Memo

To:	Aaron Miklosko Town of Maynard, MA	From:	Victor A. Olson, P.E. Burlington, MA
File:	195110237	Date:	May 7, 2019

Reference: Maynard Point 42 Summer Street Proposed Buildings – Sewer System Evaluation

PROPOSED PARKING PLAN & SITE UTILITY PLAN

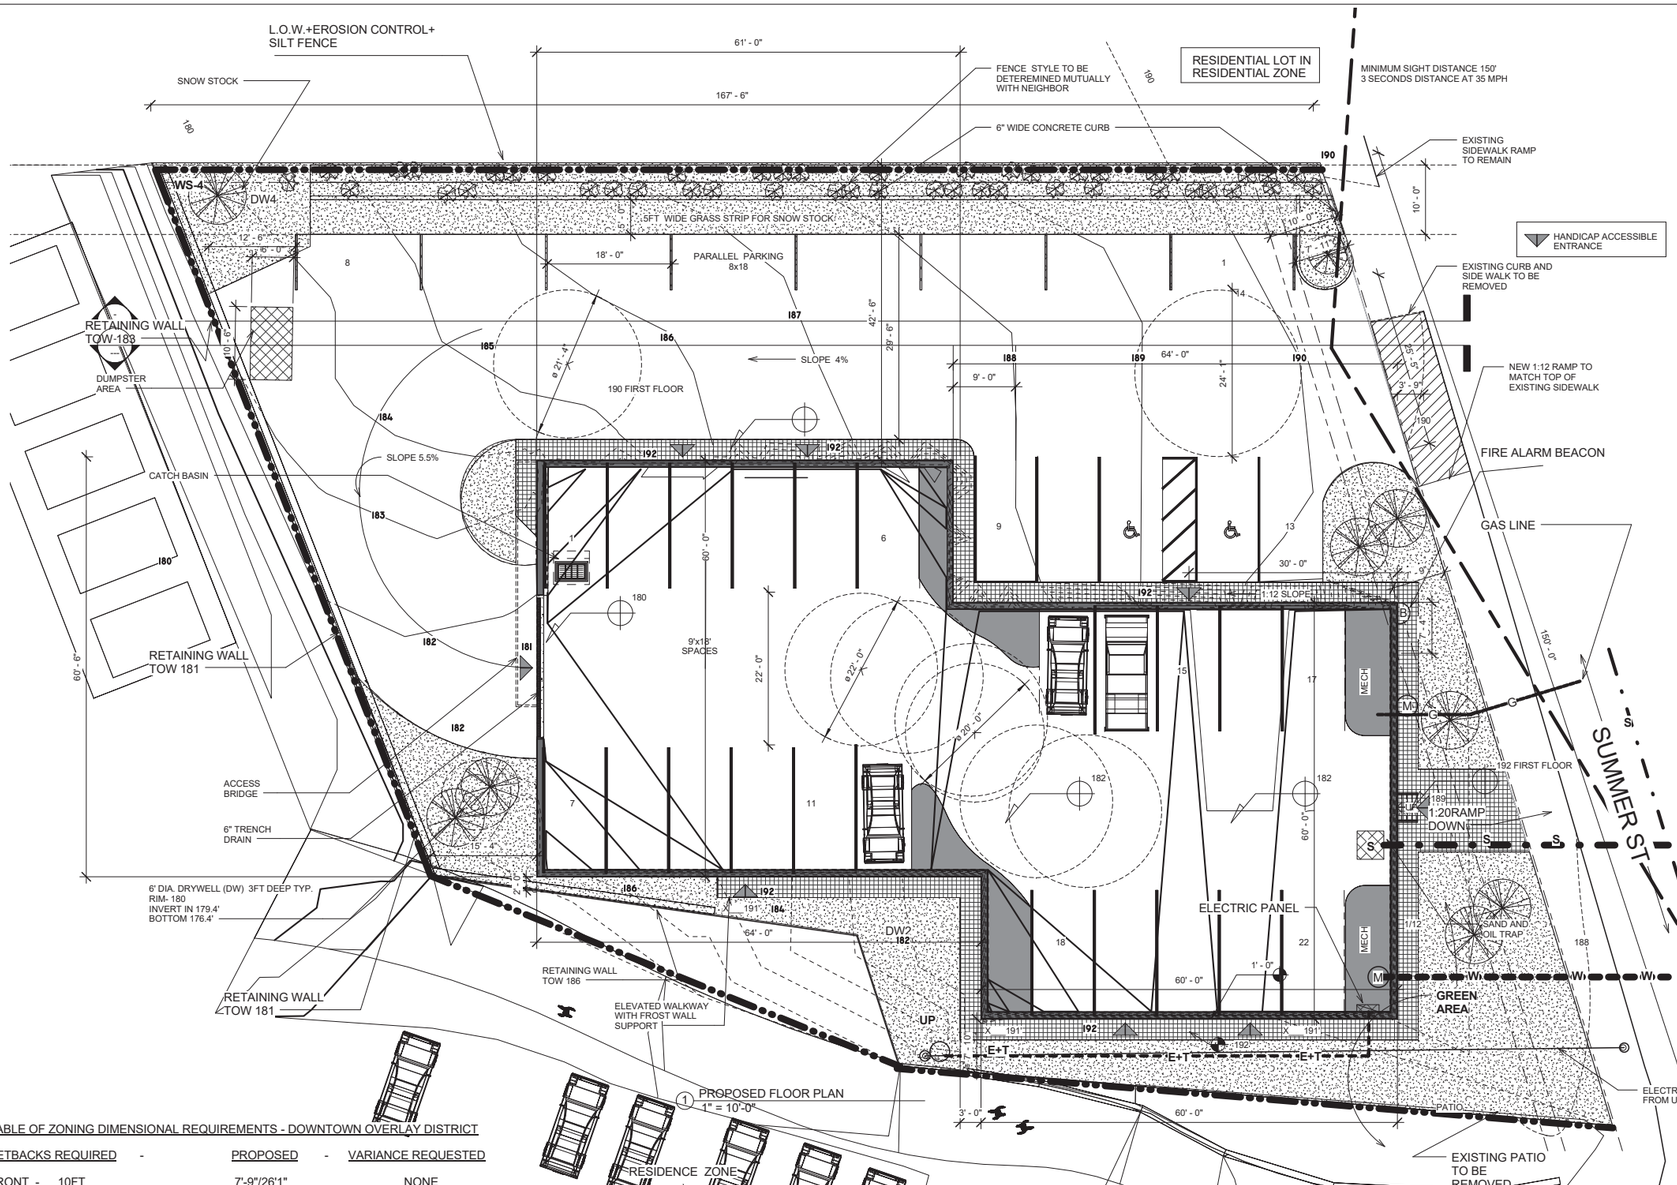
1. Provide a plan and profile of sewer connection with invert information of proposed sewer service at building and at existing sewer. Provide additional detail on site plan showing full width of street, extent of intersection of Summer Street with Brooks Street and utilities to be crossed and connected to in the public way. The site drops off more than 8 feet from Summer Street to the rear of the property and applicant should consider the need for backflow prevention in the design of the sewer profile.

2. Provide details of proposed sewer connection to existing sewer. No tap connections to the 1929 vintage 8-inch vitrified clay sewer will be allowed. A new PVC wye is required to be installed to accept the new sewer service into the existing sewer located between manhole P6 to manhole P5. PVC C900 spool piece of pipe with mechanical watertight couplings at the joints connecting the new PVC to the existing VC pipe shall be utilized. No Fernco couplings allowed on existing 8” VC sewer main.

3. The existing 8-inch sewer conveys sewage flows that will need to be maintained and bypassed during construction to add a new sewer service wye connection. Provide details of sewer bypass of 8-inch sewer required to install new sewer manhole and renovate/replace section of sewer.

PROPOSED DRAINAGE

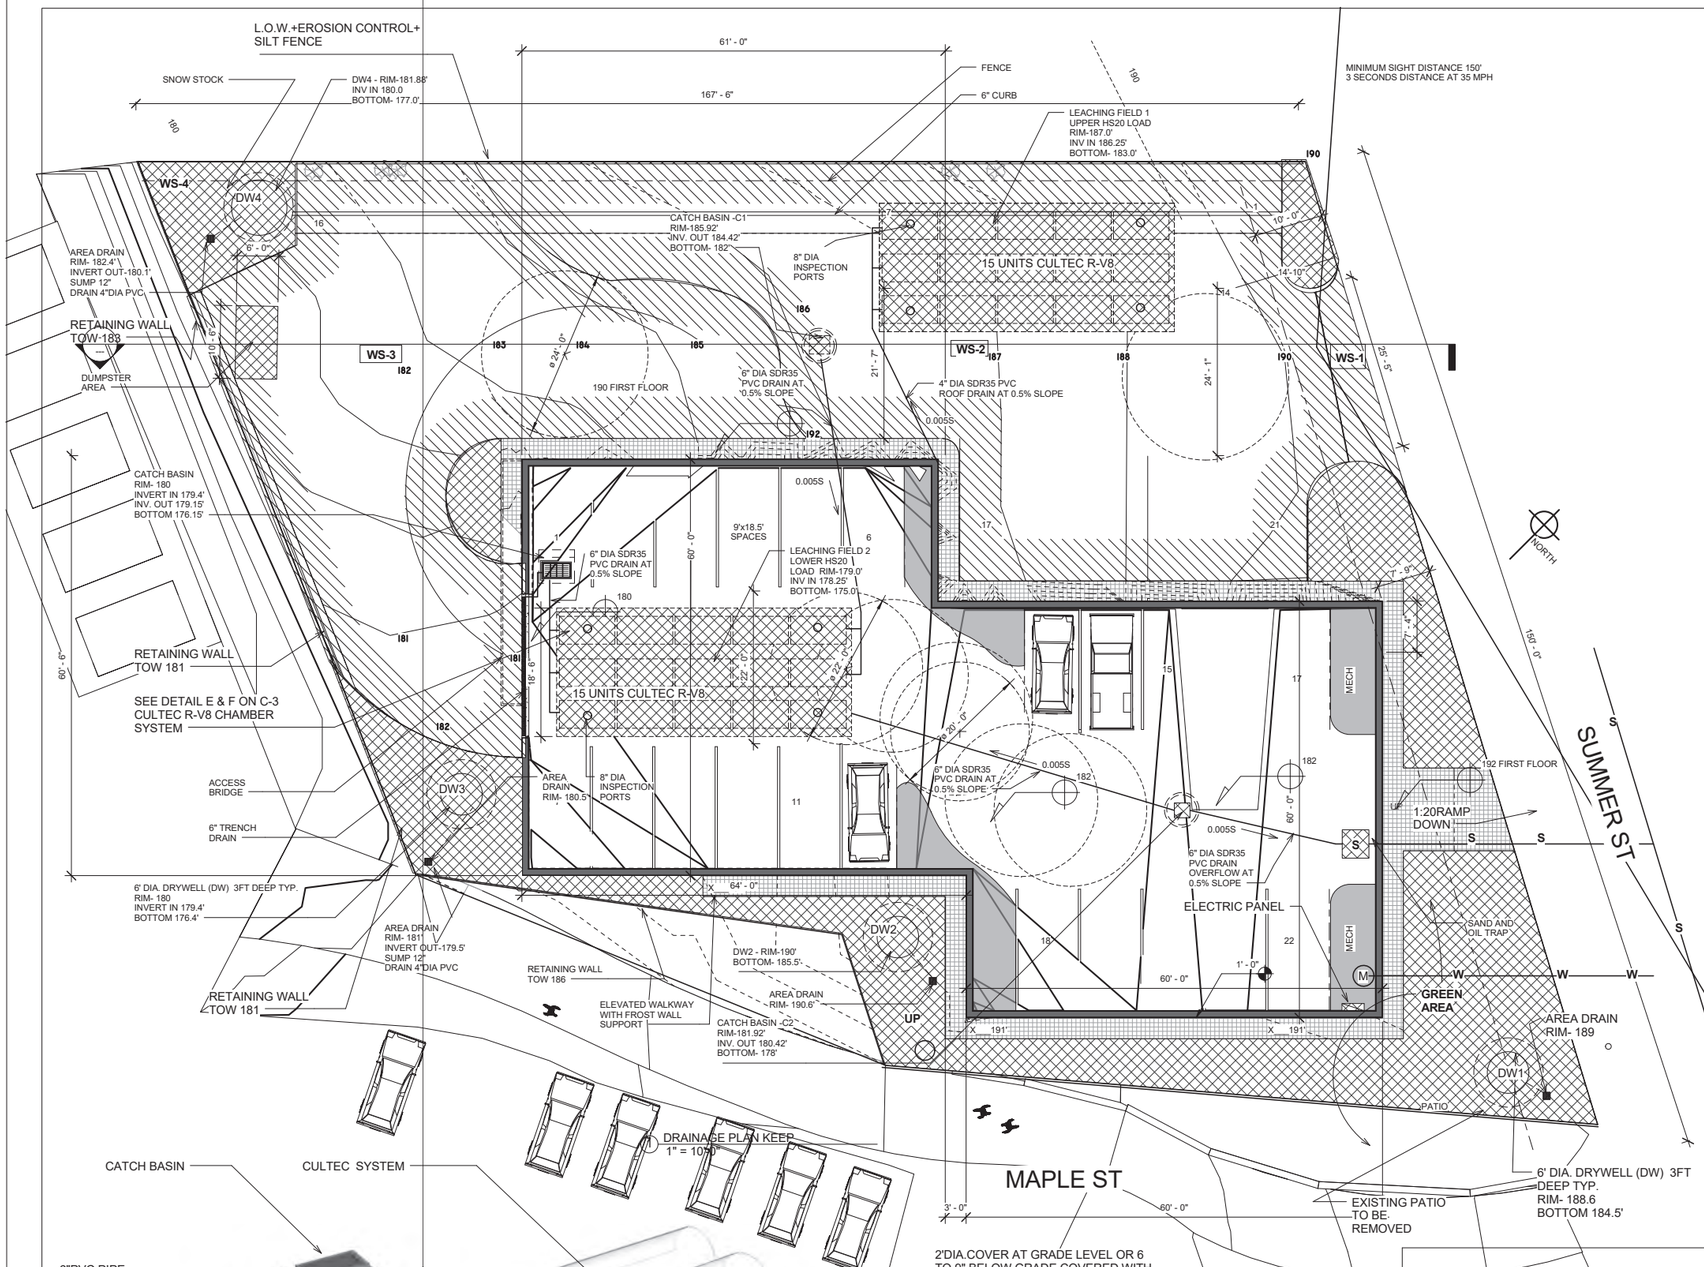
4. The proposed Drainage Plan shows and notes a PVC drain overflow from the drainage system to the sanitary sewer connection. A connection of stormwater to sanitary sewer is Not Allowed and plans should be revised for alternative means for drainage overflow to surface or to storm drainage system. The Town of Maynard has a program to remove existing sources of inflow and infiltration from its sanitary sewerage system and no new sources of inflow from drainage systems, sump pumps and foundation drains are permitted to be connected to the sanitary sewerage system. Provide new plan showing revisions.
